SPECIAL WEAPONS AND TACTICS
(SWAT) POLICE STATION
HILLA, IRAQ

SIGIR PA-05-018
JANUARY 30, 2006

SUBJECT: Report on Project Assessment of the Special Weapons and Tactics (SWAT)
Police Station in Hilla, Iraq (Report Number SIGIR-PA-05-018)

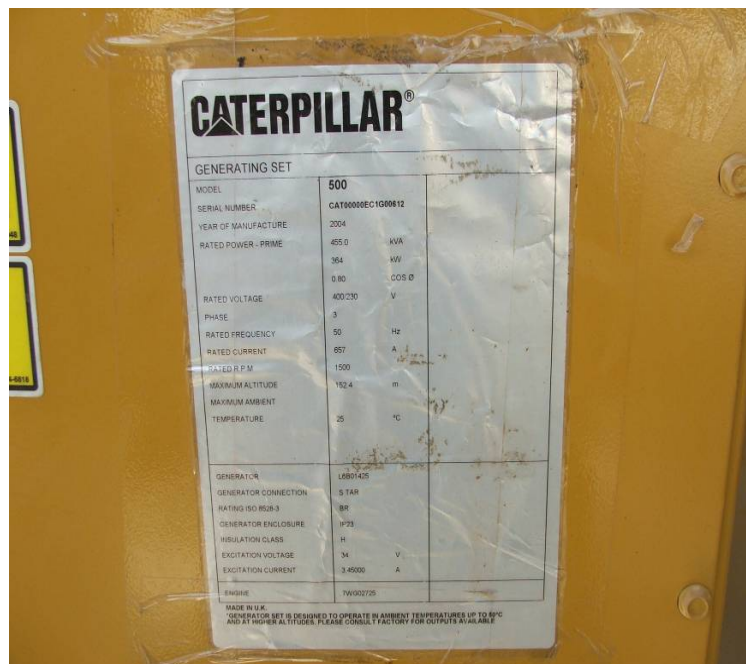
The contract required that the contractor design, select, and provide a complete electrical power generator system. The contractor submitted a design drawing for the concrete pad of the electrical power generator but did not submit design specifications for the electrical generator and catalog cuts. During the site visit, we verified an installed generator surrounded by a wire mesh enclosure. For an illustration of the exterior of the generator enclosure and the generator unit, see Site Photo 17. A paper copy of the factory nameplate was attached to the generator unit with the following information:

The engine block factory nameplate showed the Engine Serial Number as 7WG02725, although the engine block serial number was partially painted over. For illustrations of the paper copy of the generator nameplate and the engine block factory nameplate, see Site Photos 18 and 19, respectively.

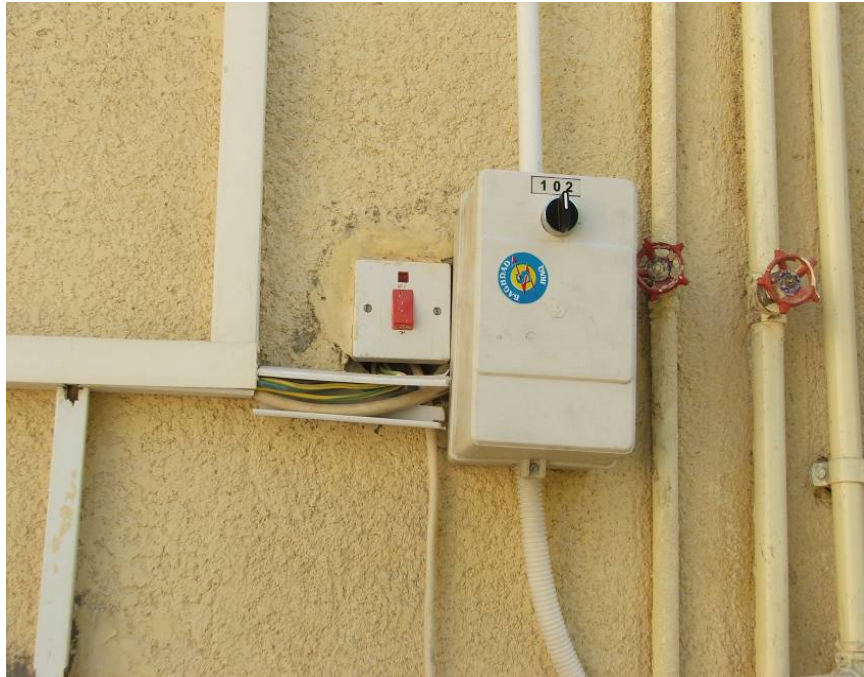
The contract's SOW required the renovation of the remaining buildings after the demolition of the damaged buildings. The SOW stated, "the second phase is the renovation of remaining buildings to temporarily house SWAT personnel as described in the attached Bill of Materials (BOM)." A complete assessment of the renovation of the existing facilities was not completed, although we conducted a walk through of the renovated buildings. Observations of cracks in the new side walks, cracks in the stucco exterior of the building, improperly installed stairwell railings (similar installation to the sleeping quarter and operations room facility), and cracks in the interior security walls are signs of poor workmanship during the rehabilitation of the facilities. For illustrations of the cracks in the front of renovated building #2 and in the interior security walls behind the Vehicle Affairs building, see Site

Photos 20 and 21, respectively. Site Photo 22 illustrates exposed electrical wires located in the exterior of renovated building 10.
